Customer Service Notice

Date: May 21, 2013

Front Bumper Outrigger Modification

Figure 1 — Operation Area Before Bracket Is Replaced

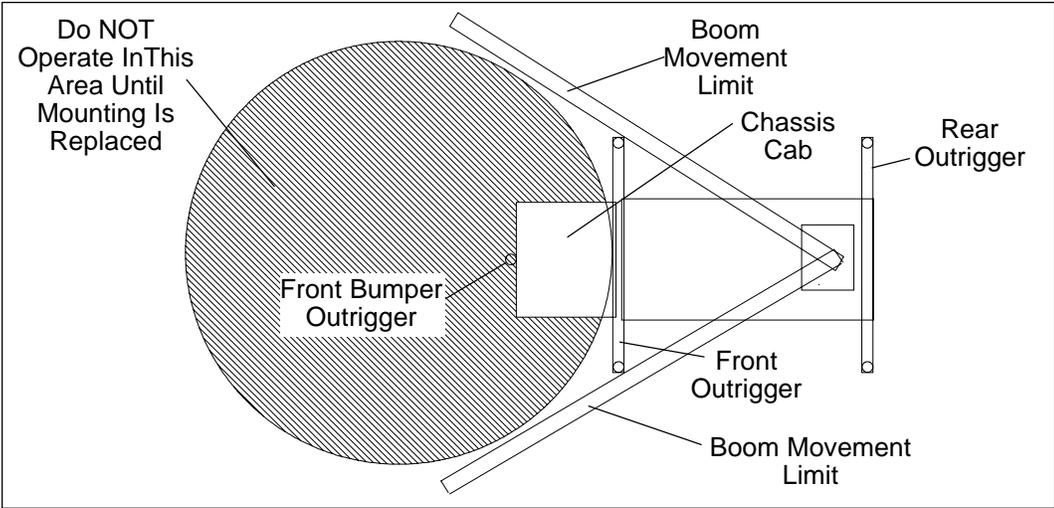
This Customer Service Notice requires customers to limit the operations of the cranes on the attached list to areas behind the forward-most outrigger until the front bumper outrigger bracket is replaced (refer to Figure 1).

Altec has received reports of the failure of a bracket attaching the front bumper outrigger on Kenworth T470 chassis. **Death or serious injury can result if the unit becomes unstable. The failure of an outrigger can cause unit instability.**

Altec will contact customers and supply technicians within 30 days of the receipt of this CSN to replace the front outrigger brackets affected. The replacement will be at no cost to customers. This CSN does NOT affect crane units mounted on other brands or models.
